Comment on:
Winde (2010) Uranium pollution of the Wonderfonteinspruit, 1997-2008
Part 1: Uranium toxicity, regional background and mining-related sources of uranium pollution
Part 2: Uranium in water – concentrations, loads and associated risks
(Water SA 36 (3) 239-278)

Response to comments made by Gunter Wendel

Figure 1
Original scatter plot used in Winde (2010)

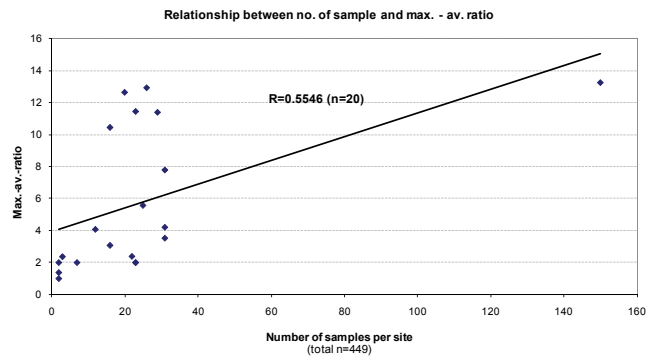
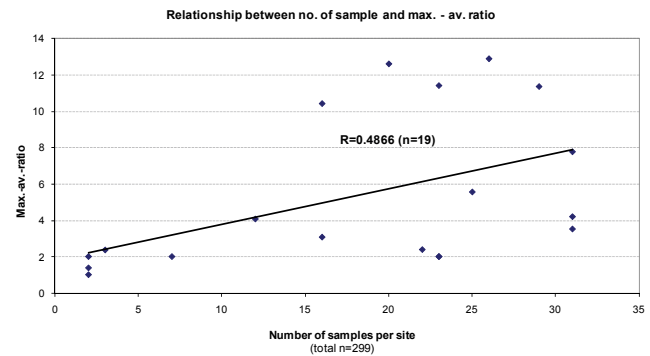
In Fig. 12 (p. 274) of Part 2, the correlation coefficient in this graph is clearly affected by a single point. Any conclusions drawn from this inference should be rejected.

This strong remark of Wendel presumably alludes to the known phenomenon that the correlations of data series can produce highly significant relations (i.e. high correlation coefficients) which, in fact, do not exist and are only caused by a single outlier value.

In such cases, graphically displaying the actual relationship between the data series in scatter plots commonly reveals that no linear regression exists. For this very reason the scatter plot was shown in the paper (Fig. 1).

While I admit that indeed, at first glance, it may seem that a single data point dominates the linear regression displayed in the diagram, this is by no means as 'clear' as Wendel asserts.

Figure 2 displays the same scatter plot after this single data point (Sample No. 150; max.-av.-ratio: 13.2) has been removed.

Apart from the persistence of a reasonably linear relationship displayed in Fig. 2, the associated decrease of the correlation coefficient from 0.5546 to 0.4866 can certainly not be regarded as large and still suggests the persistence of the stated linear relationship (in this case between the number of samples and the ratio between the maximum and average uranium concentration found in these samples).

Since the underlying assumption for exploring this relationship in the first place is that the chance of measuring extreme values (in this case maximum U concentrations) in naturally fluctuating systems increases with the number of samples taken, it would defeat the purpose of the correlation to leave out the largest study (150 samples) merely because it is an outlier amongst studies that mostly comprise much fewer samples.

The fact that the inclusion of this large study improves the correlation coefficient does not render the correlation invalid simply because it represents an outlier value, but in fact strengthens the robustness of the finding (even though the correlation itself is still comparatively weak as indicated in the paper).
